£								
DRAWING NO.			REV. B	DART AEROSPACE LTI	D.E.O. NO.	-	SHEET NO.	SCALE
D3394	LUG			ENGINEERING PROER	D3394-B-	1	SHEET 1 OF 1	NTS
DRAWN	AJS	CHECKED	<u>k</u>	MFG. APPR.	APPROVED .	MD.	DE APPR.	
DATE 0	9.11.04	DATE GW 64		DATE 09-11.04.	DATE Ø	4/11/04	DATE 09/11/04	
1			_			,		
•		Si	HEET 4 ZONE	A,1 MODIFY SECTION A-A AS S	SHOWN:			
IS:				1				i
· 				RO	UND SHARP ED	GE		
İ				<u>∕</u> − R0.	06 - 0.10			1
				2 P	L			
ļ								
1								
:								
I								
Ì								
				SECTION A-A				
1				OLOHOHAA				
WAS:			•					
MAO.	-							
ı				R0.1	25			
				2 PL				
;							FIEAGE	
						K	ELEASED 2009 -11-25	
•						9 (2009 -11- 25	
							, , 1	
1							TW	
1								
				KX/X)				
1				SECTION A-A				
!				REASON: DRAFTING ERROR		332.		
							UT @ 2000 BY DART AEDOCRACE LT

DRAWING N	NO. TITLE	REV. B	DART AEROSPACE USA	A, INC D.E.O. NO.	SHEET NO.	SCALE
D3394	LUG		ENGINEERING ORDI	R D3394-B-2	SHEET 1 OF 1	NTS
DRAWN	P	CHECKED SC	MFG. APPR.	APPROVED N	DE APPR.	
DATE	11.05.02	DATE 11.05.09	DATE //.05.08	DATE 11.05.08	DATE 11.05.09

D3394-1RG LUG (SHOWN)
D3394-3RG/-5RG LUGS (SIMILAR)
D3394-041RG/-043RG/-045RG LUG ASSEMBLIES (SIMILAR)

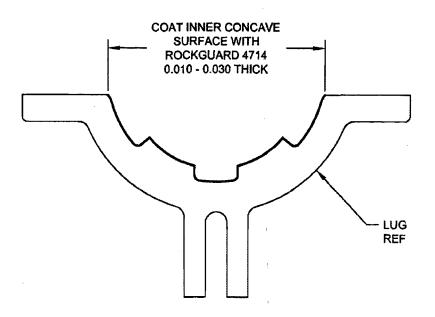
ADD D3394-xRG OPTION

D3394-xRG MOUNTING LUGS ARE INDENTICAL TO D3394-x MOUNTING LUGS, HOWEVER AFTER FINISH, COAT INNER CONCAVE SURACE WITH "PLUS ONE ROCKGUARD 4714" AS SHOWN BELOW.
